City of Evansville **Plan Commission**
Regular Meeting
City Hall, 31 S Madison St., Evansville, WI 53536
Tuesday, November 4th, 2025, 6:00 pm

SITE PLAN APPLICATION – STAFF REPORT

Applications: SP-2025-01

Parcel: 6-27-801 **Location:** 129 N Madison Street

Aerial view showing informal parking spaces over public and private land.

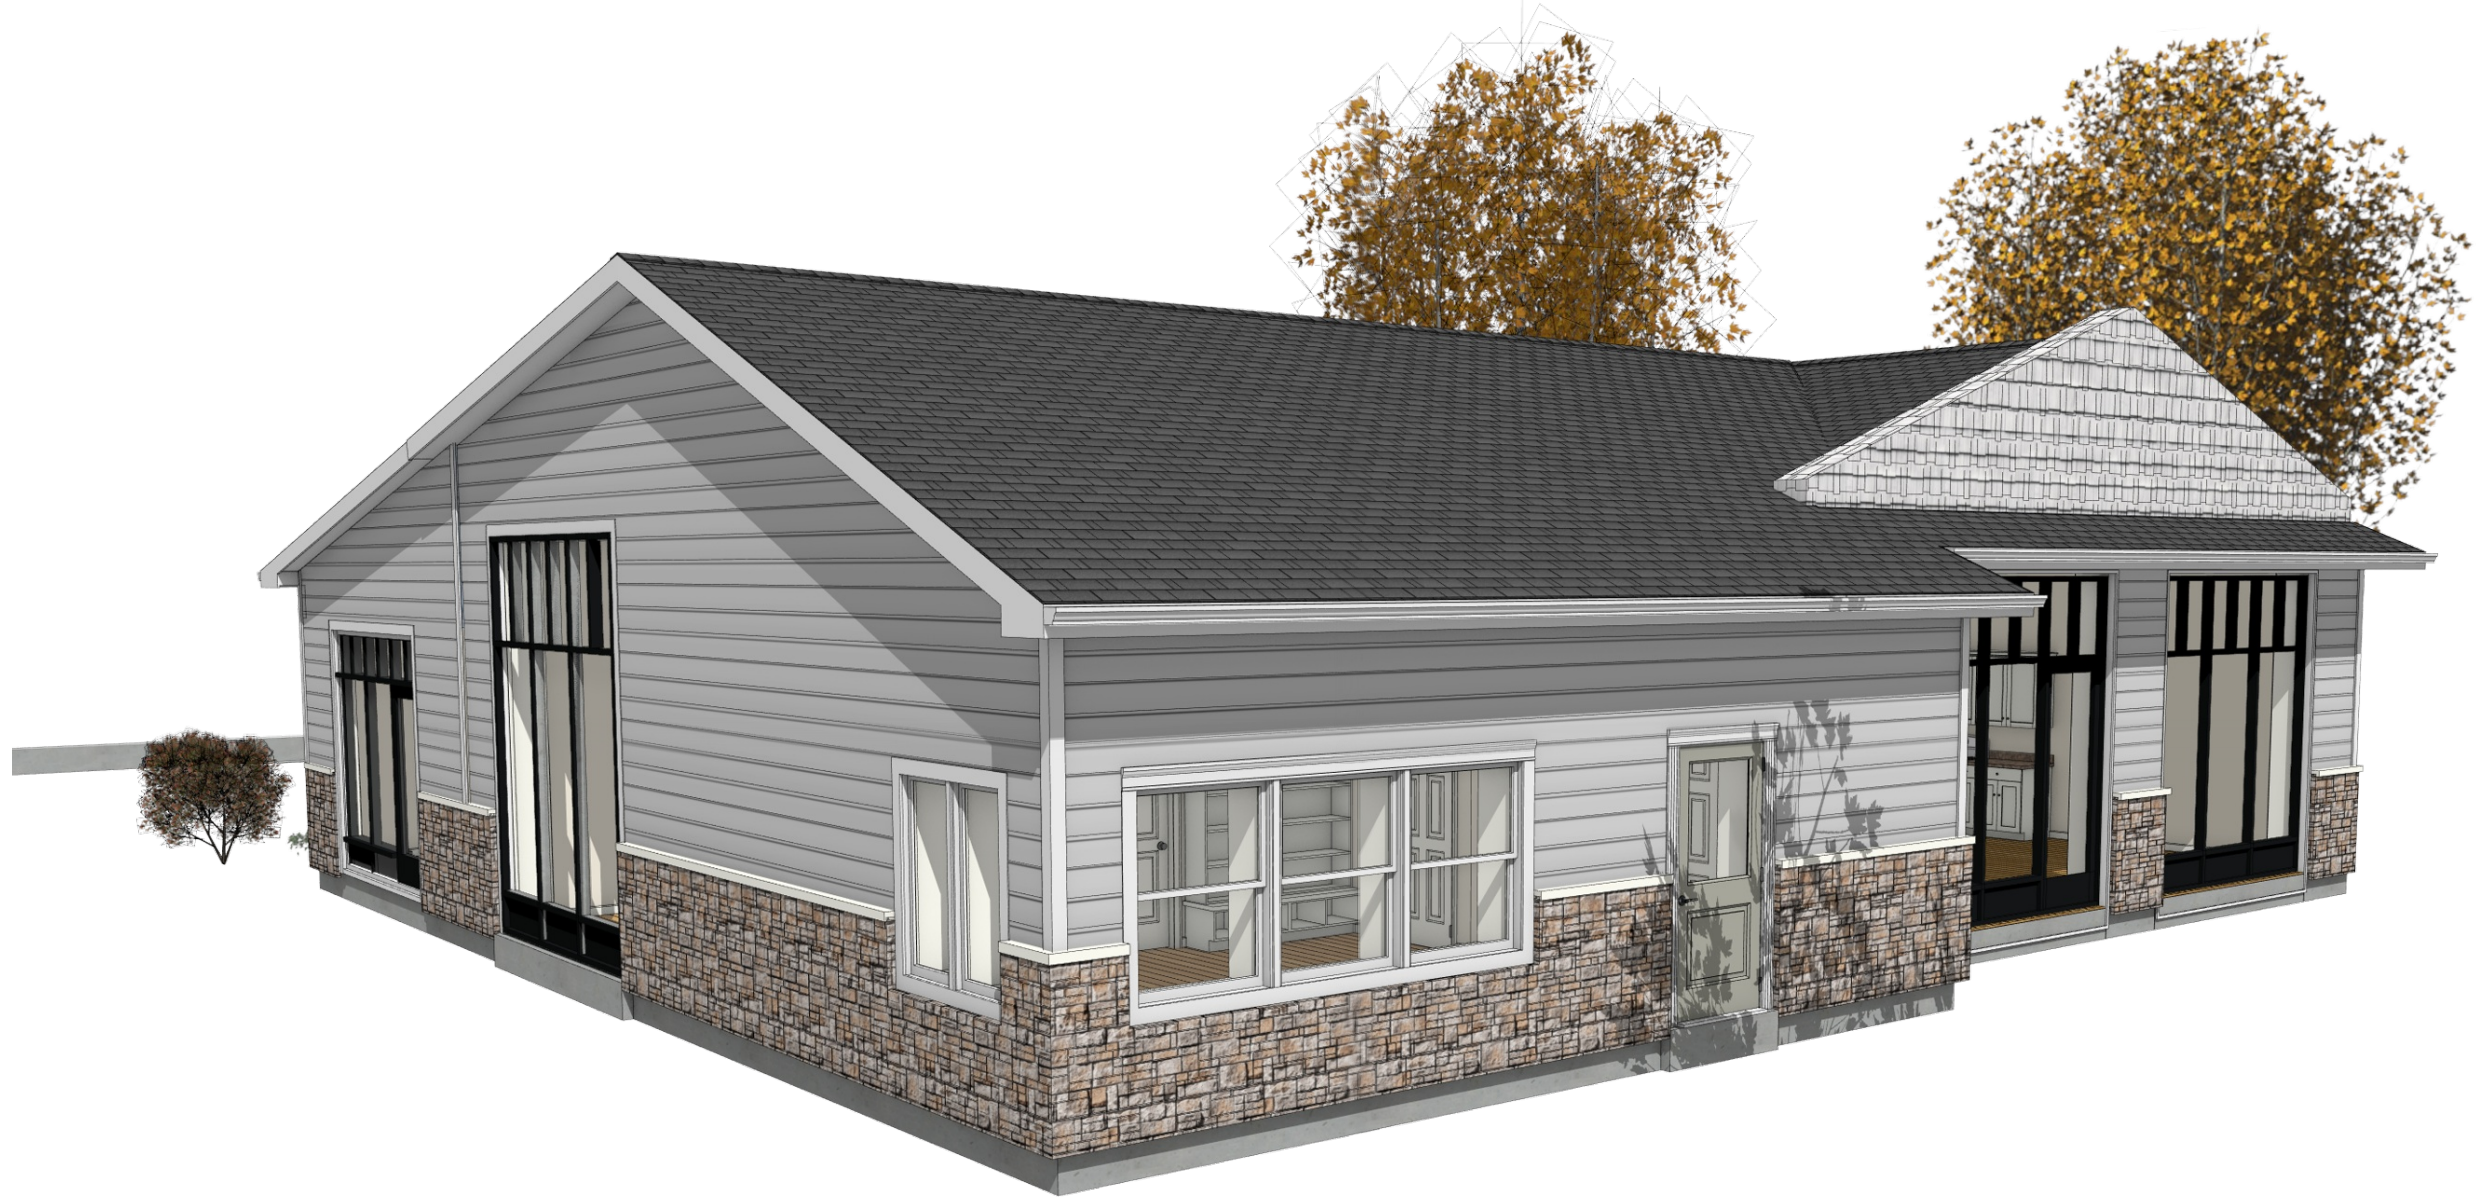
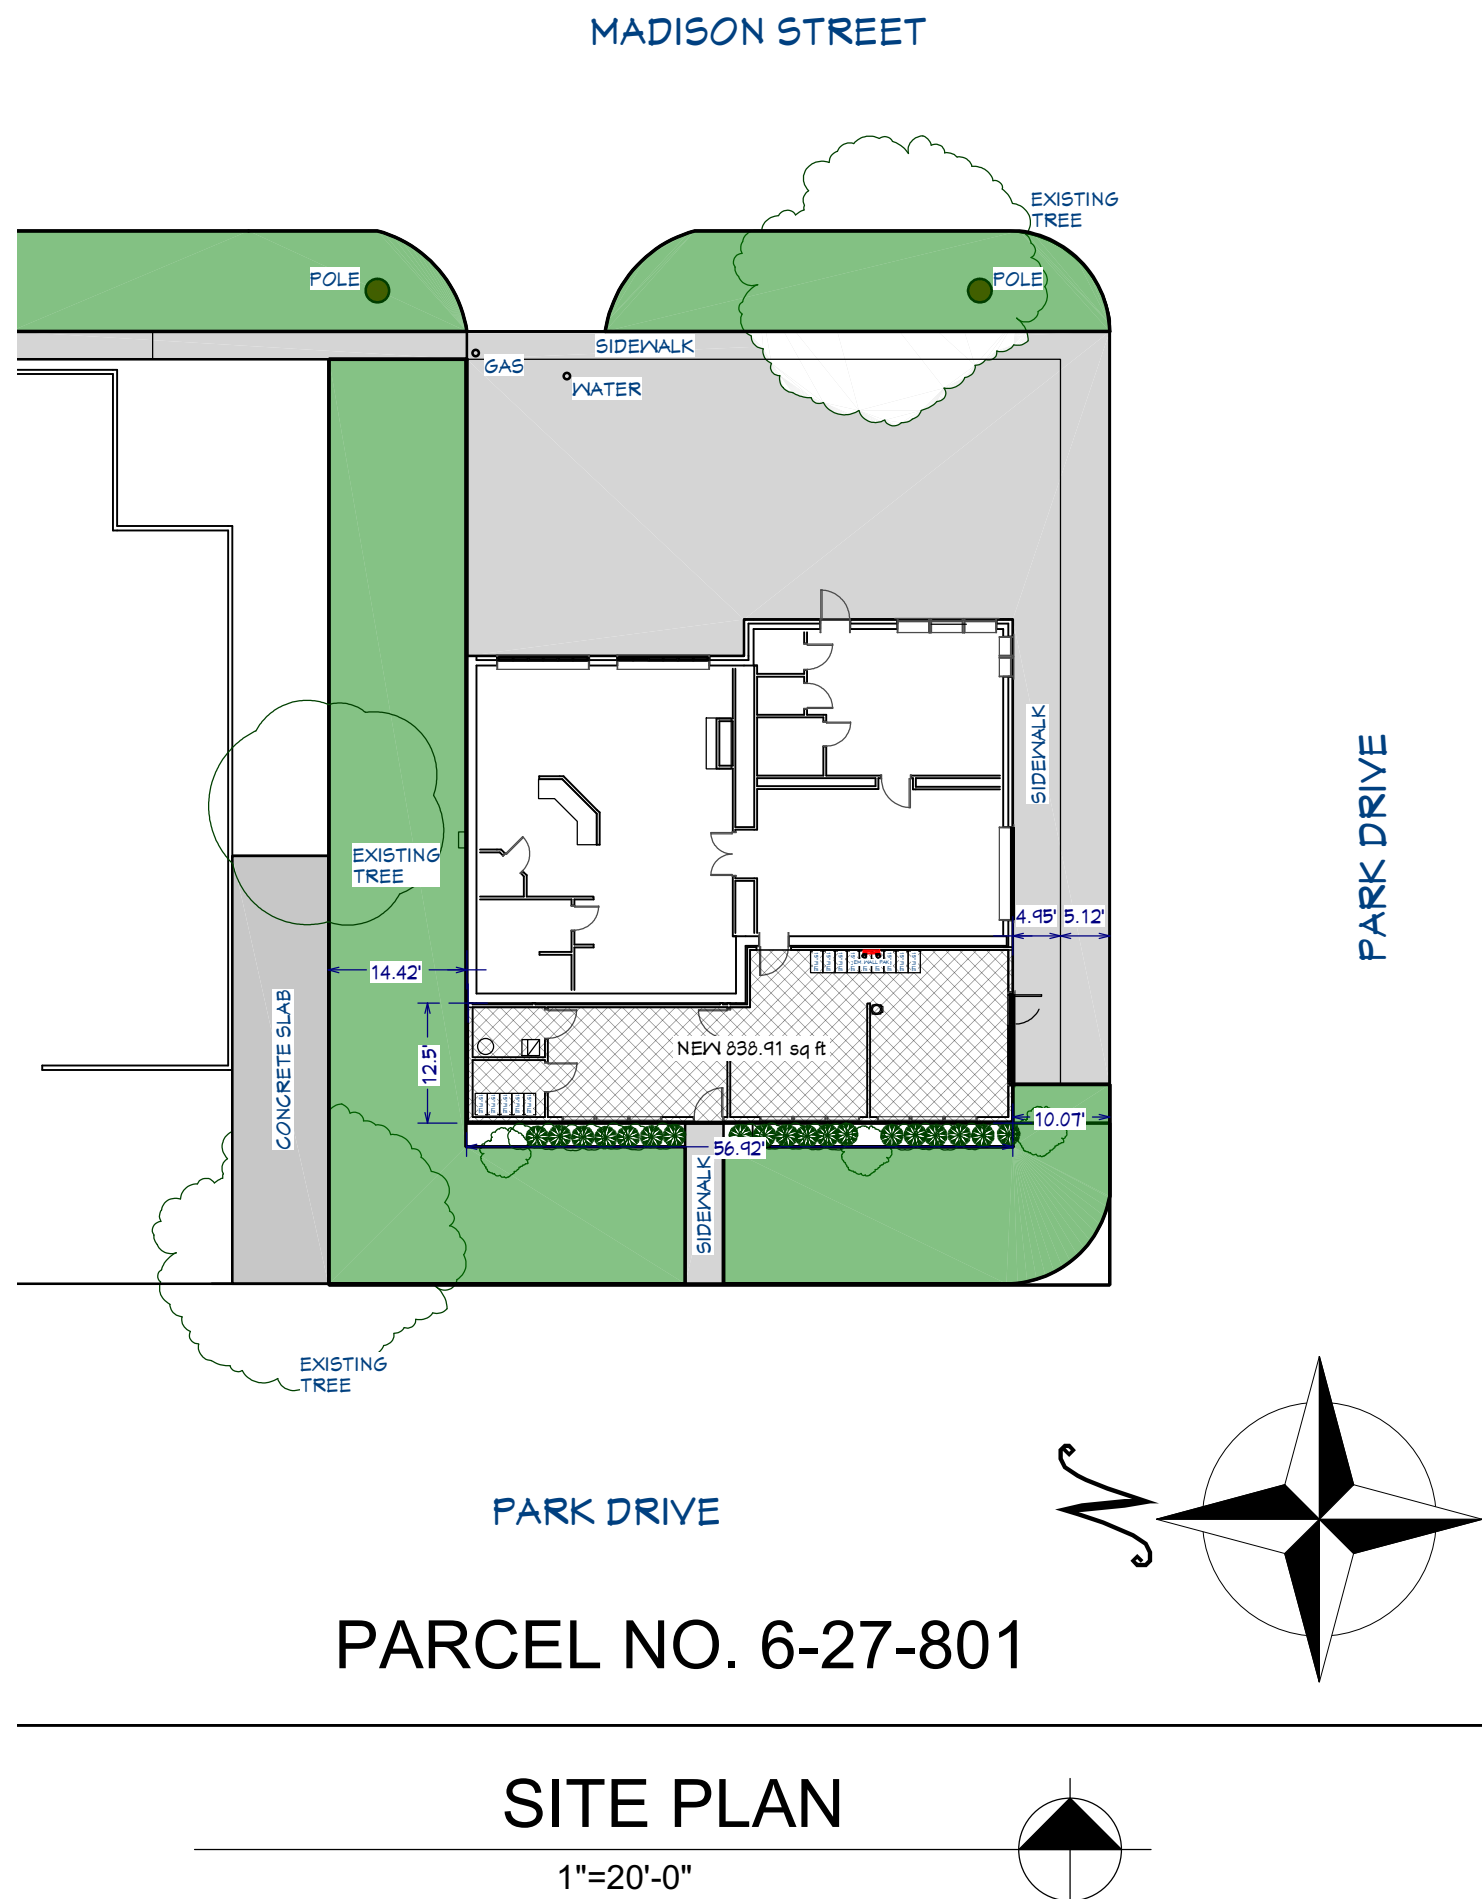
The applicant has suggested striping angled parking along the south side of the building along Park Drive. This area has long been in use as an informal parking lot (since at least 2007, likely earlier) but is technically within the City right-of-way. Striping parking spaces of appropriate size would also extend those spaces into Park Drive by about 15 feet. When building improvements were done to the interior of this building in 2018, a discussion occurred regarding the future of this encroachment. At the time, it was agreed that the parking could remain until Park Drive is either reconstructed or resurfaced. Preliminary planning by the City suggests this might occur in 2028 or along with reconstruction of Madison Street, which the Department of Transportation plans for 2028/2029.

At this time in the future, the missing curb along Park Drive will be rebuilt. The property owner would then be responsible for adding a sidewalk at the property line going around the south and west sides of the lot. The City can then stripe parallel parking on Park Drive adjacent to the new curb and potentially add angled parking on the west side of the property. This would clean up the look of the area and correct a long-time encroachment onto Park Drive.

- 1. Common Council approves Ordinance 2025-11.***
- 2. Any redevelopment on the site not to result in a building exceeding two stories.***
- 3. Parking area on south side of property encroaching into Park Drive is allowed to remain until the City reconstructs or repaves Park Drive.***
- 4. If striping is desired in the area described above in item 3, applicant will notify and work with City Public Works Department. Striping will be performed by City staff.***
- 5. After reconstruction or repavement of Park Drive, the City will require the applicant to install a sidewalk on the south and west sides of the property along Park Drive.***
- 6. Any major deviations from approved plans will require a resubmittal of application and possibly fees or enforcement action.***
- 7. Applicant records the site plan with the Rock County Register of Deeds.***

SITE PLAN

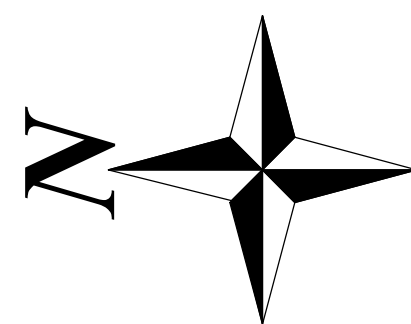
2. Site location relative to public road network	- Site is a corner lot with public streets on three sides. - Recommendation to restore curbing on south end of lot and restore grass in the right-of-way, eliminating ambiguous ownership/maintenance of paved areas within and on Park Drive
